**PLANNING COMMISSION STAFF REPORT  
ADMINISTRATIVE ITEM**

**Seasons at Denver Street Apartments  
Planned Development PLNSUB2013-00813  
448 East 400 South  
December 11, 2013**

Zoning review for a planned development of a new 4 story apartment building with 92 apartment units and two levels of parking. Request is to consolidate multiple lots and reduced the rear yard setback from 25 feet to 5 feet.

Denver Street Detail

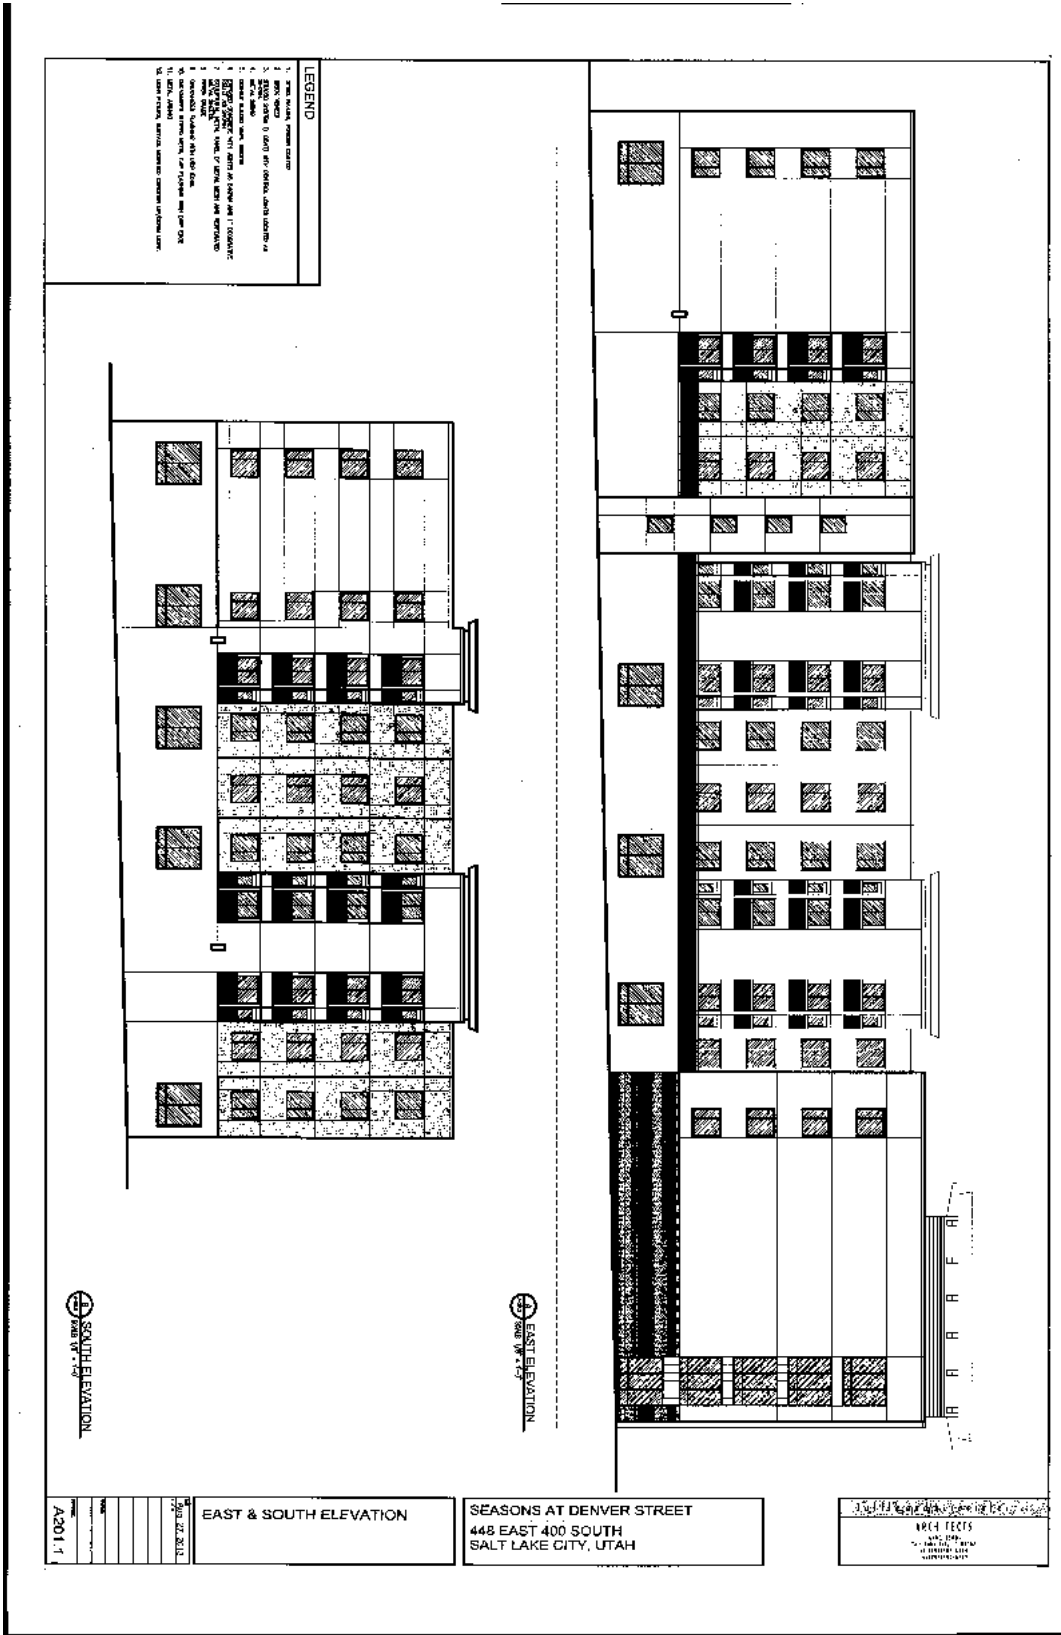
When ground floor glass conflicts with the internal function of the building other means shall be used to activate the sidewalk, such as display windows, public art, architectural ornamentation or detailing or other similar treatment. The Denver Street ground floor elevation contains a parking structure level. The ground floor elevation treatment has appropriate windows, doors, sculptural metal panels of metal mesh and perforated metal sheets and decorative exposed concrete etched panels, metal awnings and landscape planter recesses that adequately activate the sidewalk and provide street level interest to meet the purpose of the design standards.

Sidewalk exists in the public way of 400 South and on private property along the east side of Denver Street. Since there is no sidewalk on the west side of Denver Street, any sidewalk removed along the east side of Denver Street must be replaced to perpetuate the existing pedestrian corridor. The property owner must record an easement for public pedestrian access along the east side of Denver Street. To abide by ADA, the sidewalk should have no more than 2% cross slope. This presents a design challenge, but the cross slope of sidewalk can't be steeper than 2% at the loading access (Upper Parking Level) and parking lot access (Lower Parking Level). The designer may want to consider a mountable curb per APWA Std. Plan 216 so that drainage from the street gutter will not flow across the sidewalk onto private property at these vehicular access points. Prior to performing any work in the public way, or occupying the public way with construction materials or equipment, a Permit to Work in the Public Way must be obtained from SLC Engineering by a licensed contractor, who has a bond and insurance certificate on file with SLC Engineering.
